RE: Development within the Townlands of Cappagh, Clonburris Little Kishoge, Co. Dublin REG. REF. SDZ22A/0017

In response to a Planning Permission Grant issued for the subject development, please find below and enclosed our response to compliance Condition 11 related to the Civil Engineering design. Note that where relevant, additional information may be provided elsewhere by other members of the design team.

Item no. 11 SuDS

Figure 1 - Clonburris T3 Surface Water Discharge Location

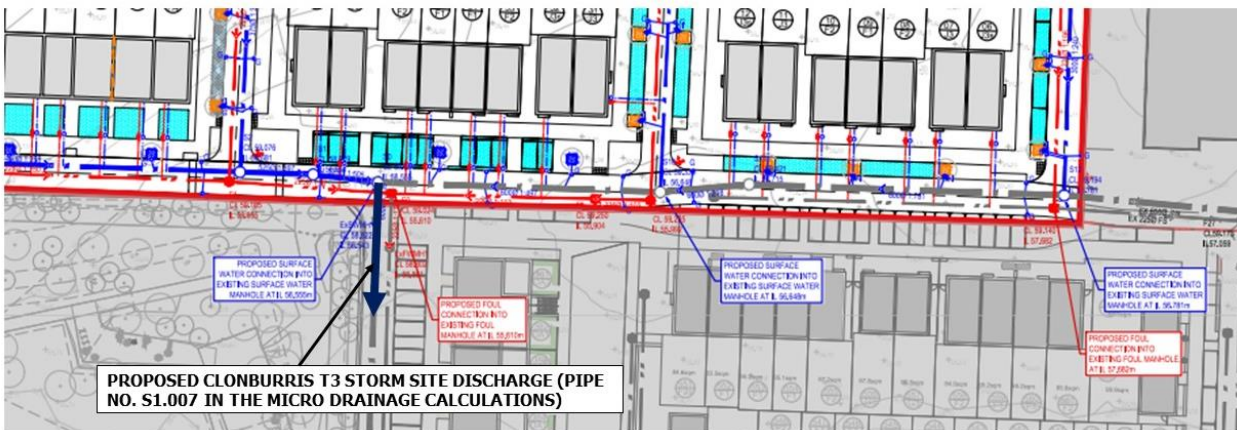
- a) Prior to commencement of development, the applicant shall submit a drawing and report to show what the discharge rate in litres/second is from proposed site. The applicant shall show how and where discharge rate of surface water is proposed for the development.

- a) As shown on drawing CLB-T3-94-SW-DTM-DR-DBFL-CE-1311 submitted for the Further Information request and attached in Appendix A of this compliance response, surface water from the subject site discharges into the adjacent Clonburris T1 surface water sewer network. Refer to **Figure 1** below which shows an extract from the drainage layout and the exact location where surface water discharges from the subject site.

drawing no. CLB-T3-94-SW-DTM-DR-DBFL-CE-1311

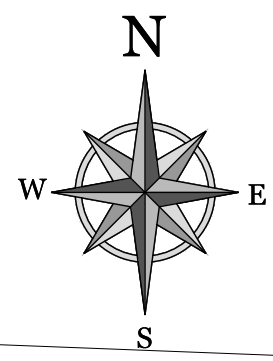
- b) Prior to commencement of development, the applicant shall submit a revised drawing showing the surface water layout that includes the location and method of discharge rate from proposed site. Show what the discharge rate for proposed site is. The applicant shall show on the drawing what surface water attenuation is provided in m3 and where surface water attenuation is provided.

- c) Prior to the commencement of development, the applicant shall provide a revised layout / landscaping plan that indicated additional e SuDS (Sustainable Drainage Systems) in proposed development such as a Green Roof, Swales, permeable paving and other such SuDS. Examples of SuDS can be found in the SDCC SuDS Guide at: [sdcc-sustainable-drainage-explanatory-design-and-evaluation-guide.pdf](#). The applicant shall provide additional details including details of filter strips, road edge detail showing how water accesses the swales/tree pits and bioretention areas, further

- c) Green roofs, swales, SuDS tree pits and bio-retention areas/rain gardens are provided as part of a suite of proposed SuDS measures shown on drawings CLB-T3-94-SW-DTM-DR-DBFL-CE-1321 and CLB-T3-94-SW-DTM-DR-DBFL-CE-1311 attached in Appendix A of this compliance response. The functioning of these SuDS elements are also described in section 3.3 of the Infrastructure Design Report as well as an evaluation against Water Quality, Biodiversity and Amenity.
